TRANSPORT DECISIONS COMMITTEE - 11 FEBRUARY 2010

SUMMERTOWN – ENTRY TREATMENTS

Report by Head of Transport

ANNEX 1

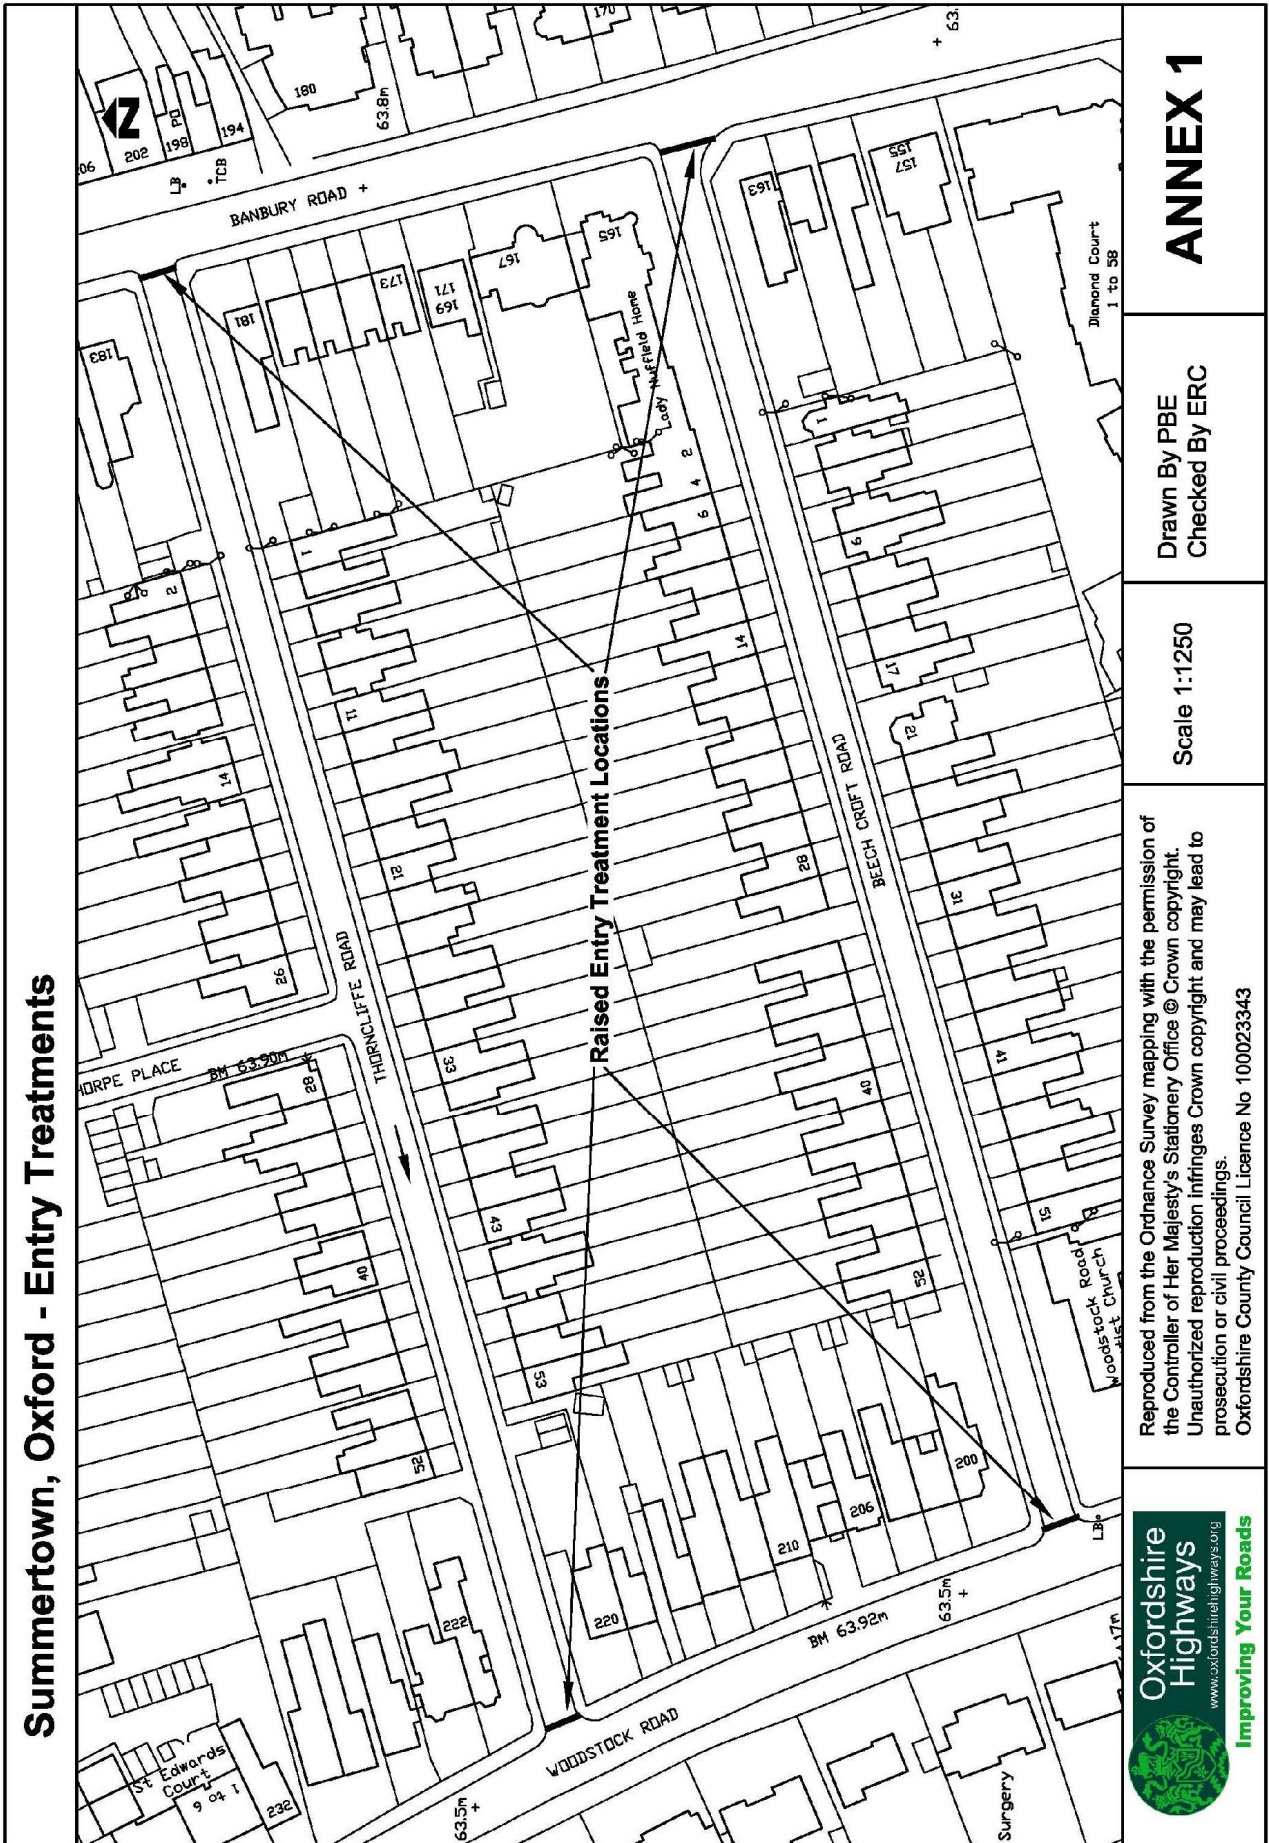
| Objection Ref. No. | No. of Objectors | Objection | Officer Comments |
|---------------------------|-------------------------|--|---|
| OB1 | 1 | Raised Surface will lead to greater nuisance from cyclists and skateboarders. | Whilst there is currently a change in level, these locations have dropped kerbs. There will be no lessening of deterrent. |
| OB1 OB2 | 2 | Mis-direction of resources where maintenance is needed to help cycling. | The aim here is to help and encourage walking by making it easier and safer. |
| OB1 | 1 | Raised entries cause discomfort to drivers and passengers with conditions such as arthritis and a nuisance to cyclists. | Ramp gradients of an average of 1 in 12 will not be uncomfortable if driven over at a reasonably slow speed. The wheelbase of bicycles is short enough so as not to be uncomfortable. |
| OB3 OB4 OB5 | 4 | Thorncliffe Road is a one-way street. Hump at Woodstock Road end is unnecessary. Humps needed along the road. Beechcroft Road is already 20mph speed limit and humps are not necessary. | The scheme is proposed to assist pedestrian access, not as a traffic calming scheme. This is necessary at both ends. |
| OB5 | 1 | Humps may require cars to slow down too quickly and may lead to an accident. | The raised treatments will be clearly visible and signed. Any manoeuvre crossing traffic must take road conditions into account. |
| OB6 | 11 | Road humps are not considered effective in reducing traffic speeds, increasing speeds between them, resulting in: Increased Noise. Increased vehicle emissions. Damage to vehicles. Sign clutter. Discomfort to car users. Access problems for emergency services. Increased maintenance. | The issues mentioned here would be relevant if a series of humps were proposed, in order to provide traffic calming. However, the proposal is for one raised area at each end of each street. This proposal would not result in the problems alleged here. It will, however, provide benefits for pedestrians in those locations, by providing an at-grade route and making drivers aware of the need to consider pedestrians at these locations. |

| Concern Ref. No. | No. Concerned | Concern | Officer Comments |
|---|---------------|---|--|
| CO1 | 2 | Want design to be a 'pavement' <u>not</u> a 'road'. Would like to see a different surface so it shows the pedestrian route and as a "gateway" entry to a shared-space street. | This is exactly what the raised areas are not meant for. They are intended to assist the passage of pedestrians. Signifying an entry to a 'shared-space' would only be true for Beech Croft Road (when their "DIY" scheme is implemented) in any case, but the application of a different surface may indicate a priority that does not exist. Whilst extra cost of material and maintenance may be considered small, it is an extra expense that may create more difficulty than benefit. |
| CO2 CO3 CO4 CO5 CO6 CO8 CO9 CO11 | 7 | Welcome slowing of traffic but not needed at Woodstock Road and humps could be hazardous for turning traffic, so put humps in the middle. | The scheme is proposed to assist pedestrians at each end of the street, not as a traffic calming scheme. The raised areas will be clearly visible and marked. |
| CO5 | 2 | Would be more cycle friendly if there was a gap in the hump. | Whilst this is true, it conflicts with the intention to make the route more pedestrian friendly. Wheelchair and pushchair users would have difficulty negotiating the ups and downs. |
